**CITRUS COUNTY CENTRAL LANDFILL  
GROUNDWATER  
INVESTIGATION REPORT**

**RESPONSE TO FDEP REQUEST  
FOR ADDITIONAL INFORMATION**

The following information is provided in response to the Florida Department of Environmental Protection (FDEP) May 10, 2006 request for additional information prepared by John R. Morris, P.G. Information is provided in the order requested in the referenced correspondence. In each case, the DEP request is repeated with the response immediately following.

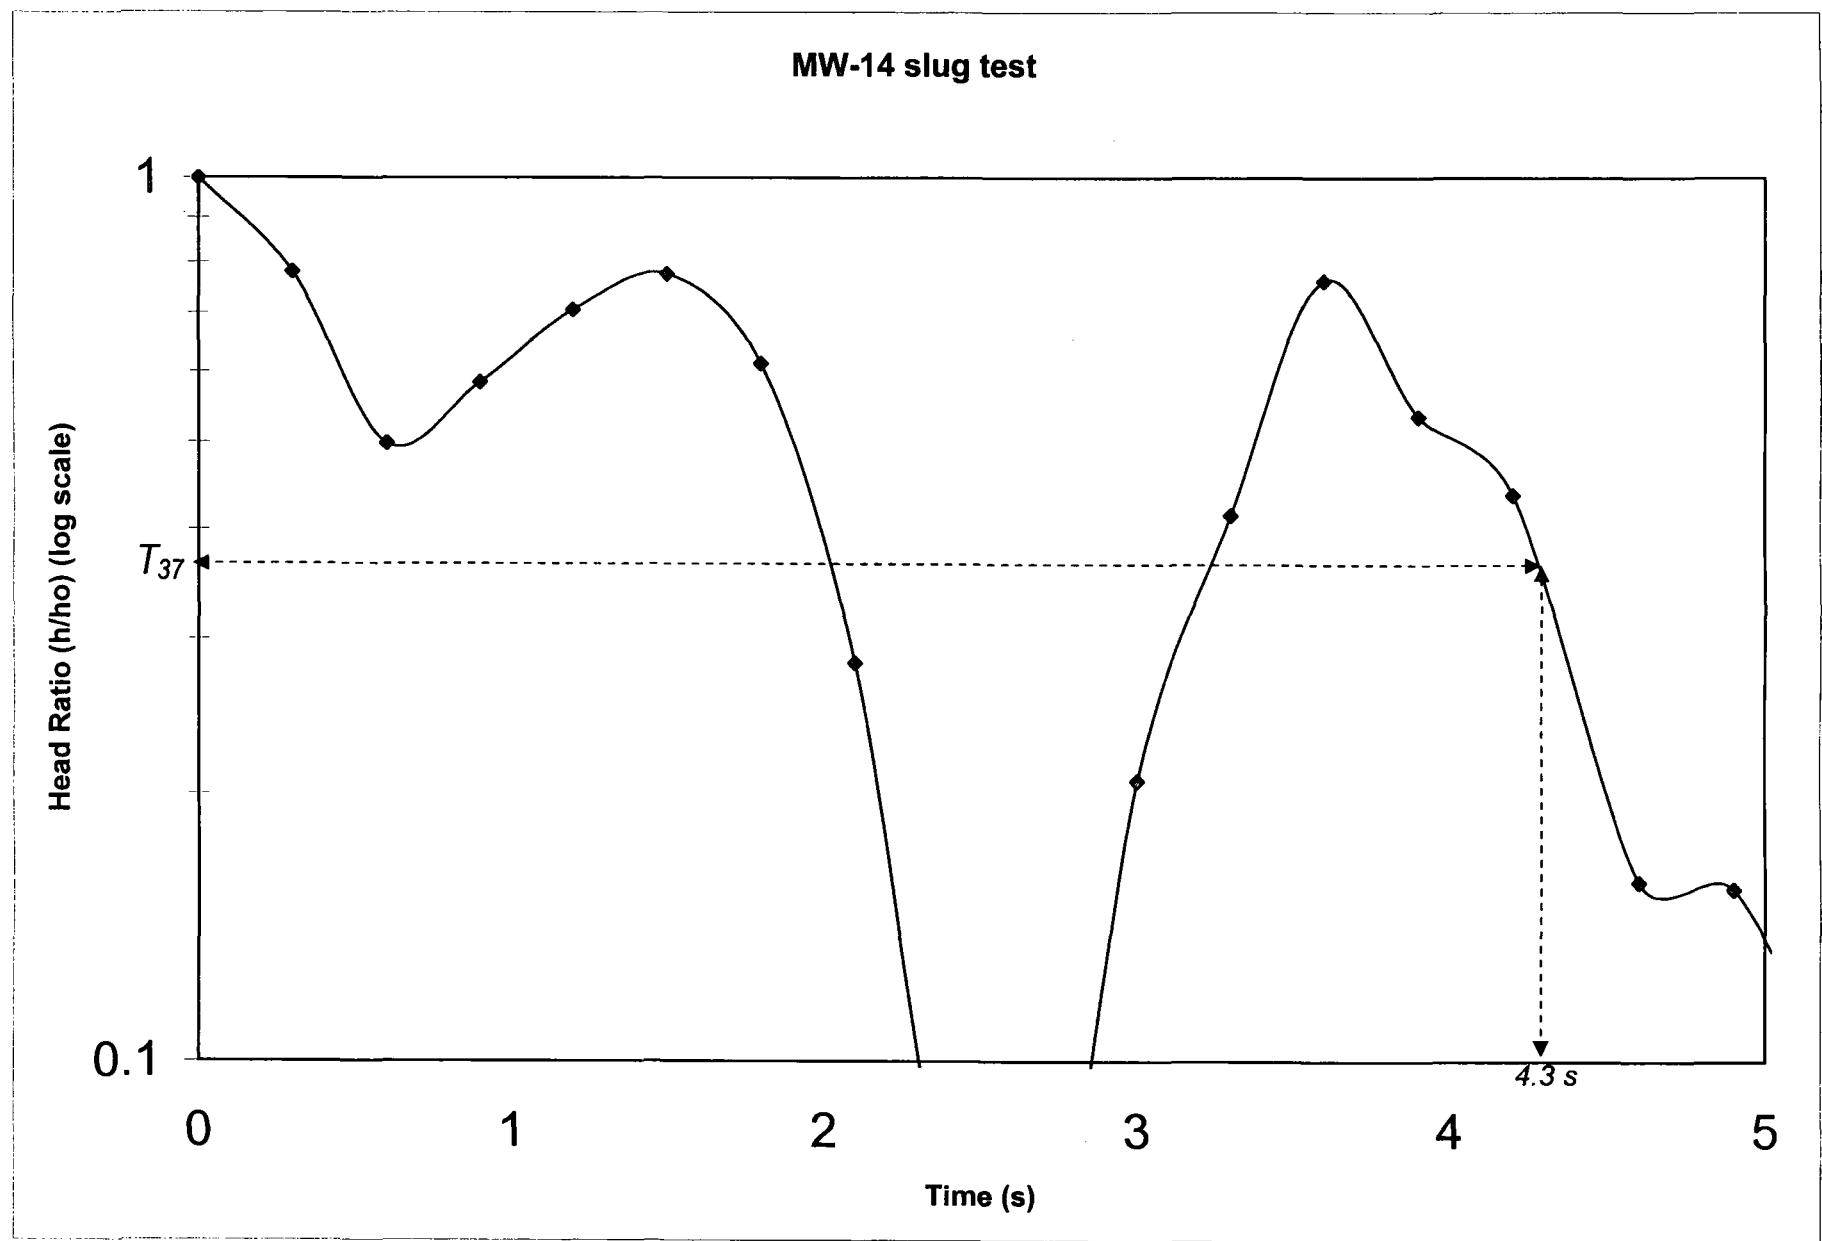
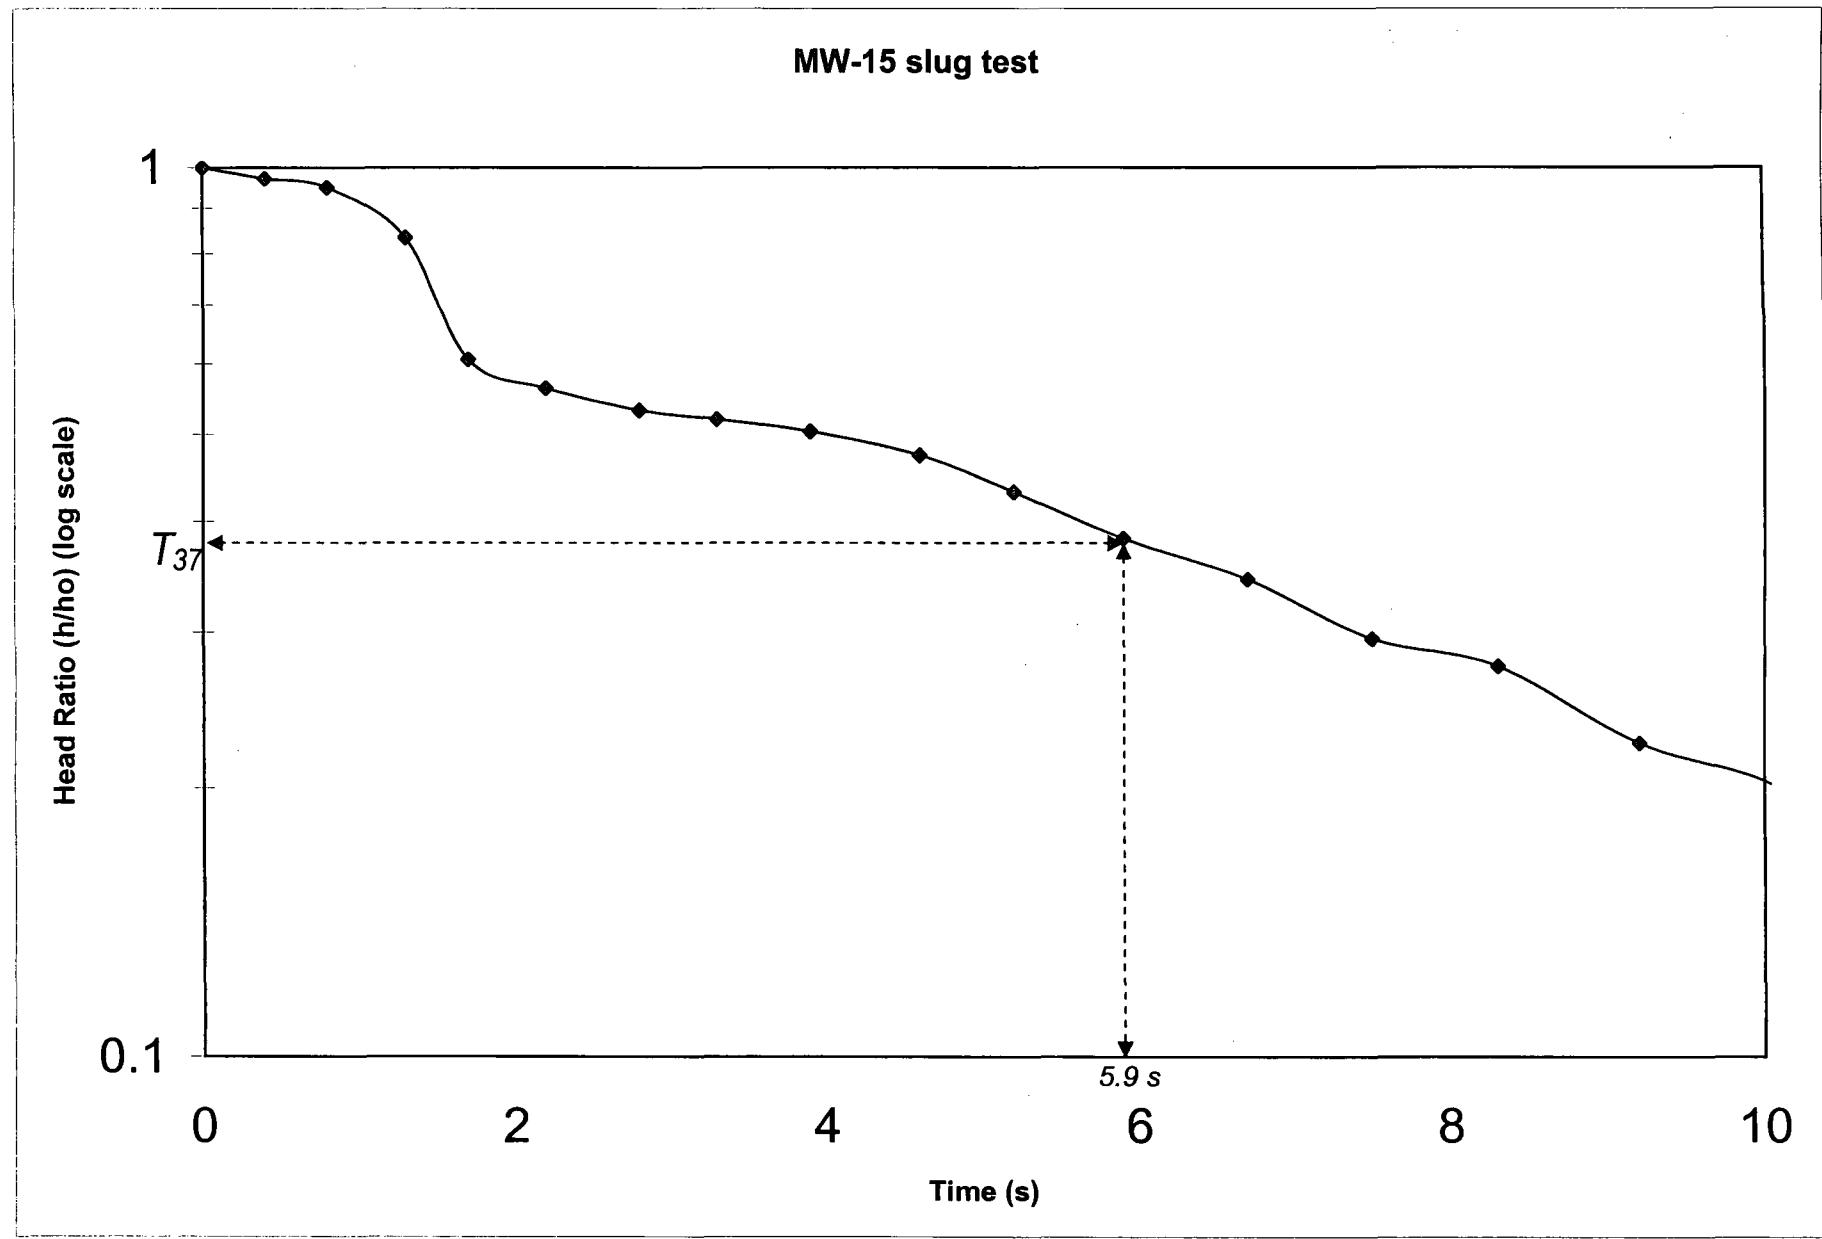
*Comment 4: Field data of residual head vs. time collected during the hydraulic conductivity testing (“slug out” tests) conducted at wells MW-10 through MW-17 were provided in Appendix G. Please have the Respondent submit revisions to Appendix G to also include the graphical solutions prepared for each set of slug test data.*

**Response 4:** Appendix G has been revised (Attachment 1) to include the graphical solutions prepared for each set of slug test data.
